UNITED STATES PATENT AND TRADEMARK OFFICE

APPLICATION NO.	FILING DATE	FIRST NAMED INVENTOR	ATTORNEY DOCKET NO.	CONFIRMATION NO.
10/691,503	10/24/2003	Yasuaki Kuwata	117604	7211

Office Action Summary	Application No. 10/691,503	Applicant(s) KUWATA, YASUAKI	
	Examiner Phillip Nguyen	Art Unit 2828

DETAILED ACTION

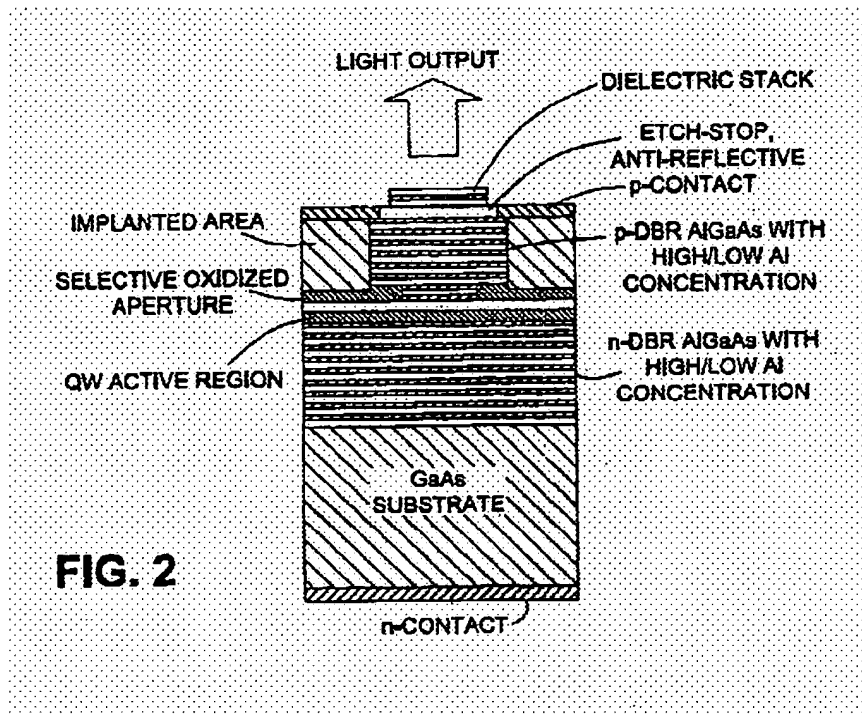
Claims 1-7 are rejected under 35 U.S.C. 102(e) as being clearly anticipated by Aggerstam et al. ('690).

With respect to claims 1-2, see Fig. 2 (above).

With respect to claim 3, Aggerstam discloses a top of the laminate is partially covered with an electrode (p-contact) so that an emission aperture “can be” defined; and the block member is provided on top of the laminate and located in the center of the emission aperture. Applicant is suggested to rewrite the claim to avoid using the word “can be defined” and replace with “is defined”.

With respect to claim 4, Aggerstam discloses the laminate having a mesa. It is noted that the laminate does not include implanted area as shown in Fig. 2. Aggerstam also teaches an emission aperture (p-contact and implanted area) and the block member (dielectric stack) having a shape related to an outer shape of the mesa.

With respect to claim 5, Aggerstam discloses the laminate comprising a current confinement layer (selective oxidized aperture) having conductive region (central region); and the block member having a size smaller than a size of the conductive region (col. 5, lines 16-18).

With respect to claim 6, since both block layer (dielectric stack) and electrode (p-contact) are on the top of the laminate and not overlapped each other, they can be formed simultaneously. However, this claim is apparatus claim and the structure of the device is mainly concerned, not when the layers are formed.

With respect to claim 7, Aggerstam discloses the block member blocking light of a fundamental mode among the multimode laser light (col. 5, lines 31-40).
